Re: Application #135675/FO/2022

I wanted to follow up directly on our objections to Block 2 within this application; at this stage we are unable to add comment through the Planning Portal and the developer appears to be continuing to try and justify its inclusion into the scheme. It is worth reiterating that this objection is not one of anti-development but a request for something better that doesn't have a severely detrimental impact on local residents, neighbouring public realm as well as our cities heritage assets. Below I have summarised key areas that form the basis of our objection in an exec summary and added further detail in the body of this email; all of which on their own make a strong case as to why this application should be rejected, but collectively, I'm struggling to see how there is any justification to approve this scheme as it stands. In legal terms, the inclusion of Block 2 is wholly contradictory to local and national planning policies and will remove the public benefits promised under the recently approved Port Street scheme.

Fig. 14: Annual Safety at Ground Level, Proposed Development with Cumulative Surrounds

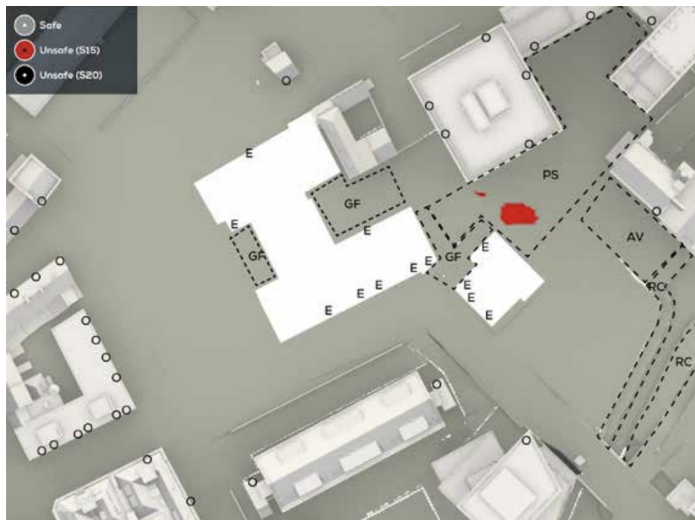
2. **Wind:** Below (which has been taken from P.18 of the Wind Report of this application; 135675_FO_2022) depicts a significant area of proposed public realm which is considered unsafe for a sub-group of our society; table 03 in this report describes this as **"Unsafe for frail individuals, or cyclists"**. This was not identified in the wind report of the Port Street Application (132489/FO/2021) so it's logical to deduce this unsafe area has been created by this application.

I am at a loss to try to comprehend how this council would consider this acceptable given the intended use of the space. The public realm as part of the Port Street Application (132489/FO/2021) was welcomed as much needed green space by neighbouring residents. I have depicted the intended use of the space from the landscape strategy (132489_FO_2021), as you can see, this is a seating and grass area which will not only become unusable but also unsafe should the council approve this application.
